317 Finchley Road
London NW3 6EP

Basement Impact Assessment
Audit

London Borough of Camden

Project Number: 12336-73
Rev: F1

Figure 1: Vertical settlement due to horizontal movement of wall [Ref 1]

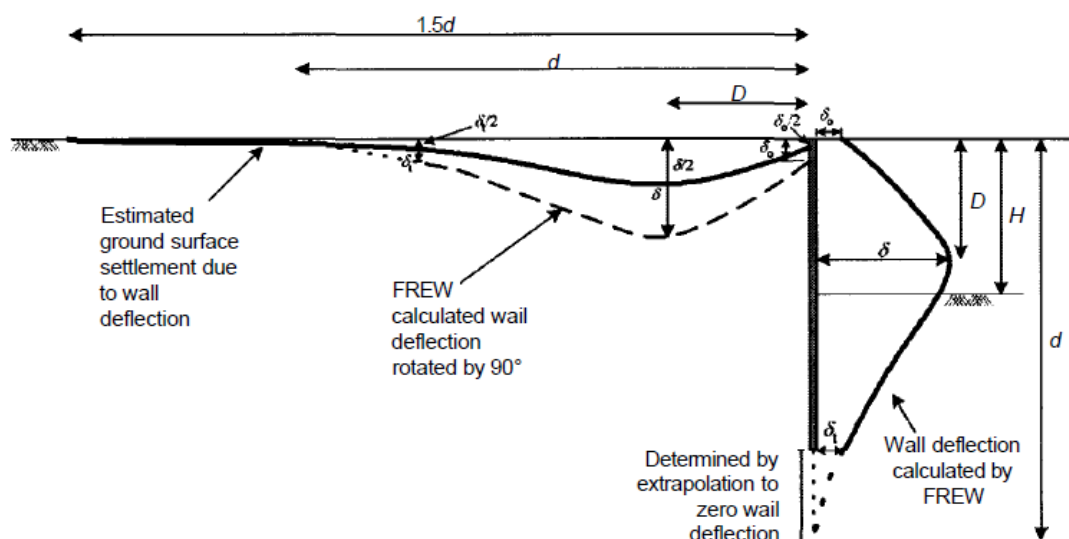
- 4.17. Queries were raised on approach used in the GMA, the installation movements and the foundation levels of the neighbouring properties (assumed to be at 4.50m bgl) as it was unclear how these were determined.

The approach used was to determine the vertical ground movements of the surrounding area based on the lateral deflection profile of the retaining wall, as described in CIRIA C580 [Ref 1] and reproduced in Figure 1. CampbellReith identify that this relationship was determined from a “top down sequence with a diaphragm wall embedded in stiff clay with a significant overlying thickness of coarse grained soils”. This is considered applicable for the following reasons:

- Away from the corners of the excavation, where the dominant behaviour is that of a vertically spanning wall, the behaviour of a secant piled wall would be similar to that of a diaphragm wall.

- The proposed temporary propping scheme will result in a high stiffness system, similar to that achieved by a top down construction sequence. The excavation required to install the first line of piles (approximately 1-1.5 m) is similar to that which would be required for a top down sequence. This is further validated by the shape of the deflection profiles from the Oasys FREW analysis, which closely resemble that of a top down construction sequence.

- The case histories used to determine the above relationship consisted of 16 m and 18 m deep excavations, retaining up to 10 m of coarse grained soils overlying the stiff clay. The proposed retaining walls are also embedded entirely into stiff clay, and support between 0 – 4.7 m of coarse made ground overlying London Clay with a maximum

excavation depth of approximately 8.5 m. While the proposed depths are less than the case histories, the soil profiles contain sufficient similarity to indicate that the calculation method will provide a suitably accurate approximation for this scenario.

- Data shown in Figure 2.11(b) of CIRIA C580 (reproduced as Figure 2) and subsequent correlation, is based on a range of sites which included bored pile, diaphragm and sheet pile walls wholly embedded in stiff clay. A comparison is shown in Appendix B between this correlation and the more detailed calculation approach undertaken, and verifies the choice of calculation method.

Figure 2: Vertical settlement due to piled wall installation [Ref 1]

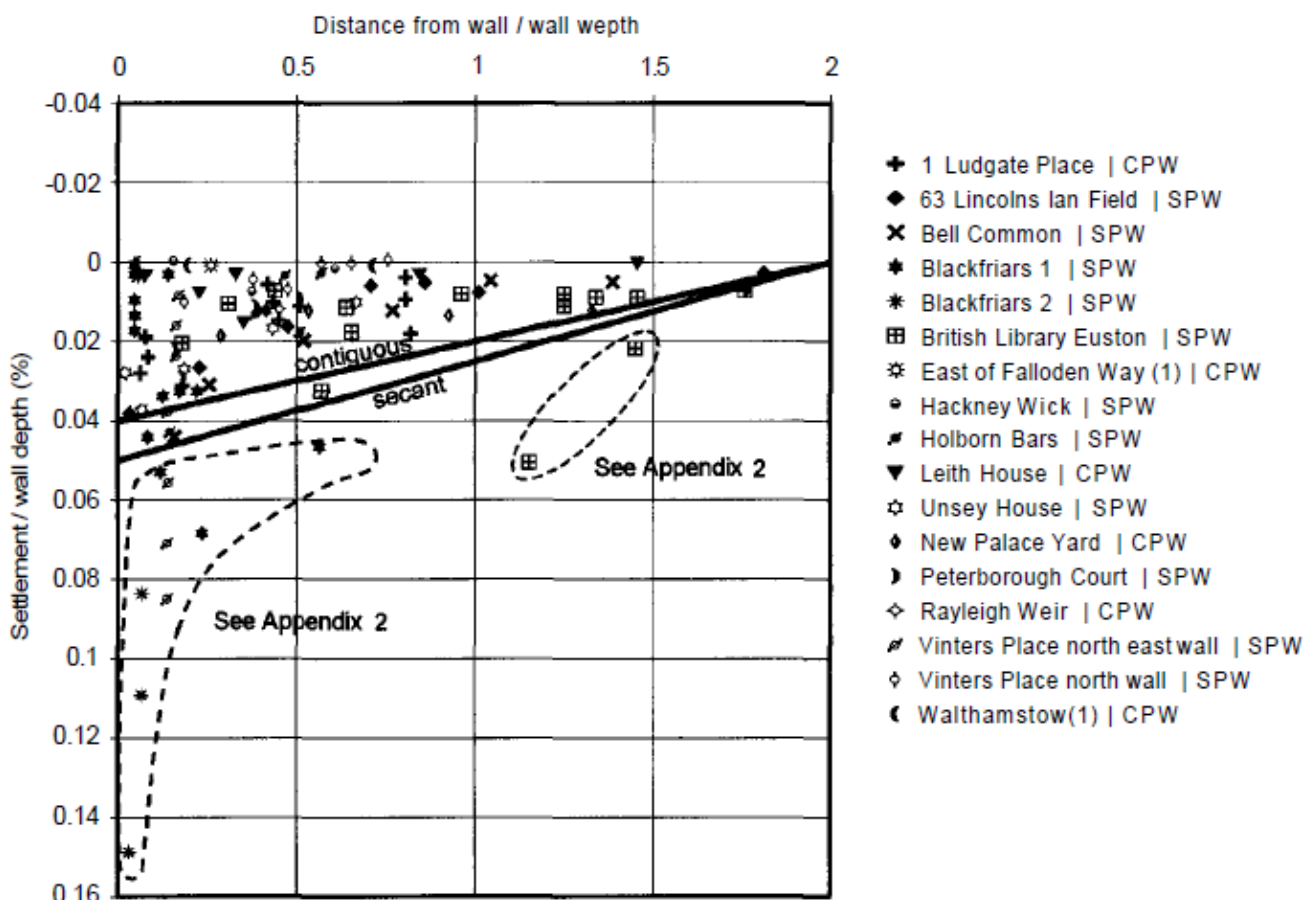
CampbellReith has advised that further information is required to justify the ground movement calculation approach, provide a basis for the neighbouring foundation depths, and to consider ground movements due to pile installation.

Predicted ground movements due to pile installation have now been considered, with calculations included in Appendix B. The calculations are based on CIRIA C580, Table 2.2 and Figure 2.8(b) [Ref 1], reproduced as Figure 2 below. It is noted that the correlations are based on secant piled walls embedded into clay, and are therefore considered to be a suitable (albeit limited in size) sample set.

The computed values are expected to be conservative on the basis that the correlation is not based on the mean of the case study values, but that it appears to be based upon the largest measured deflections across all of the studies. Furthermore the case studies are based on pile diameters of 0.75 m to 1.2 m in diameter (although note that not all case studies listed the diameter) and therefore it is expected that for a 0.6 m diameter piled wall the ground movements would be less than suggested by Figure 2.

Figure 4: Total predicted vertical ground movements

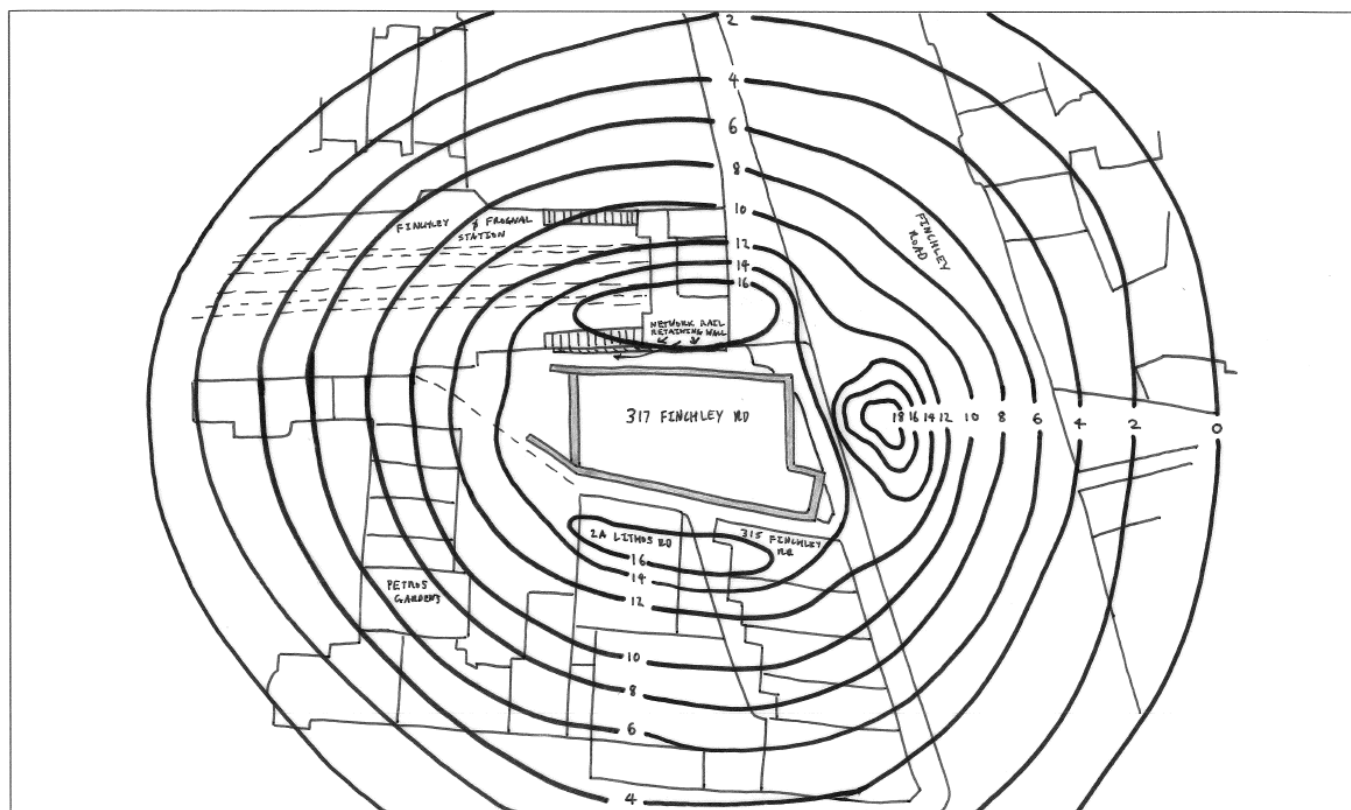
- 4.18. Justification for the approach used was given in the supplementary information provided (dated 4 August 2016, Appendix 3) together with the neighbouring property foundation depths. The response indicates the foundation depths were assumed based on discussions with the neighbours and that a sensitivity check on the basis of shallower foundation depths did not alter the damage categories predicted. It is accepted the use of Frew and reference to Figure 2.16 of CIRIA C580 to calculate movements behind the wall is broadly applicable for this stage of assessment, however, it was requested via email that the horizontal movements due to pile installation be included as these did not appear to have been considered in the revised ground movement assessment.

The revised anticipated ground movements, subject to final temporary works design, are shown in Figures 3 and 4. Figure 3 shows the ground movements due to horizontal movement of the retaining walls, while Figure 4 shows the total vertical ground movements due to piled wall installation and horizontal movement of the retaining walls.

In reality, it is considered that the actual settlement profile will be somewhere in between these values due to the likelihood that the movements due to piled wall installation are an overestimate, for the reasons discussed in Section 2.2.3.

Drawing No	J2680-SK-022		
Project	317 FINCHLEY RD	Status	INFO
Drawing Title	INDICATIVE PROPPING SCHEME		
Date	01/08/16	Drawn by	PCW
Scale	N/A	Revision	X1

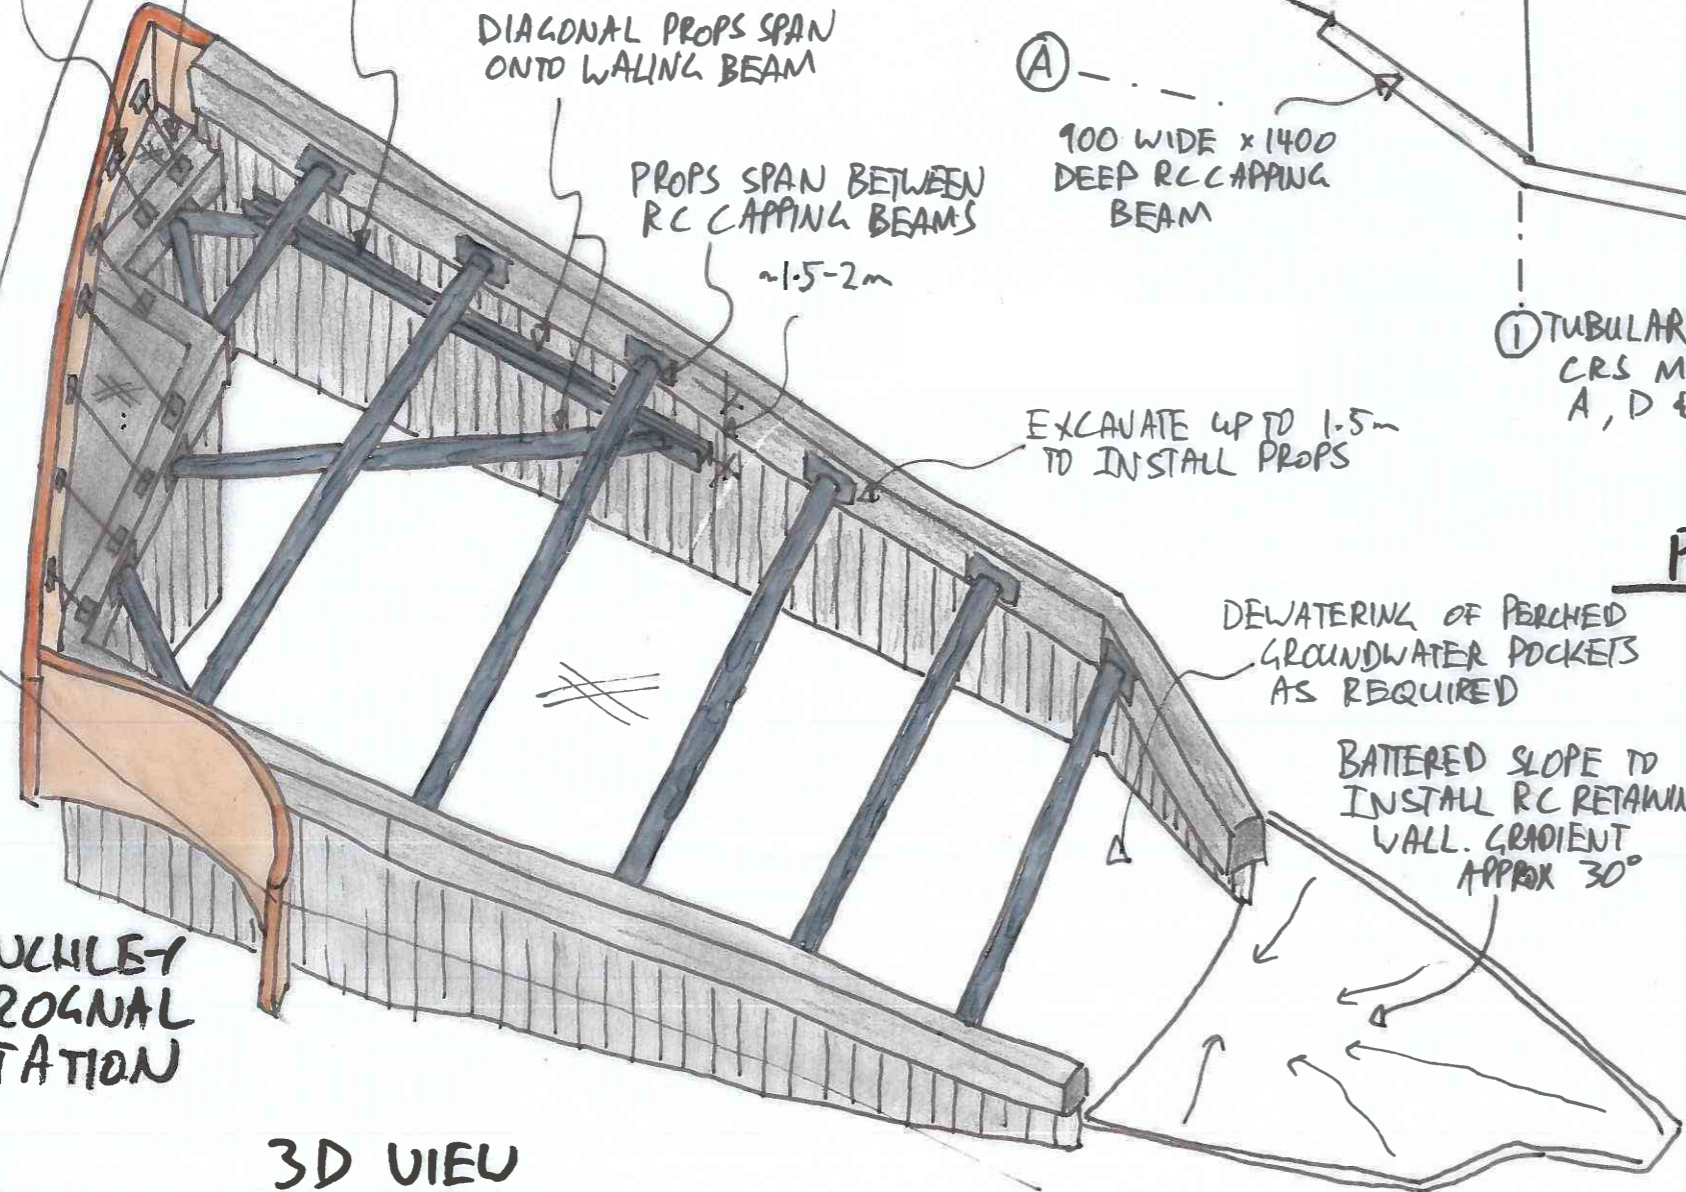
- 4.5. The BIA includes a construction sequence which assumes demolition of the existing building to ground level; installation of temporary propping followed by demolition of existing ground and basement slabs; installation of secant piled retaining wall with the softer, female piles stopping at just below the new basement level and the hard, male piles continuing to depth to support vertical and horizontal loads. The temporary works propping system will be developed by the Contractor but assuming it is sufficiently stiff to meet the requirements of the ground movement analysis, it is accepted that the proposed piling solution will minimise ground movements, and hence potential damage to neighbouring structures, whilst allowing any groundwater flow to remain unimpeded. It was requested that an indicative temporary works propping solution be provided following the initial audit.

- 4.6. The additional information provided includes an indicative temporary works scheme which appears acceptable with regard to its general arrangement of propping members. A supporting calculation which is also provided produces deflections in the props which appear significant,

however, and these should be reassessed when final construction design details are submitted for the relevant approvals processes.

An indicative temporary propping scheme was requested by CampbellReith and is included as Appendix A with supporting calculations.
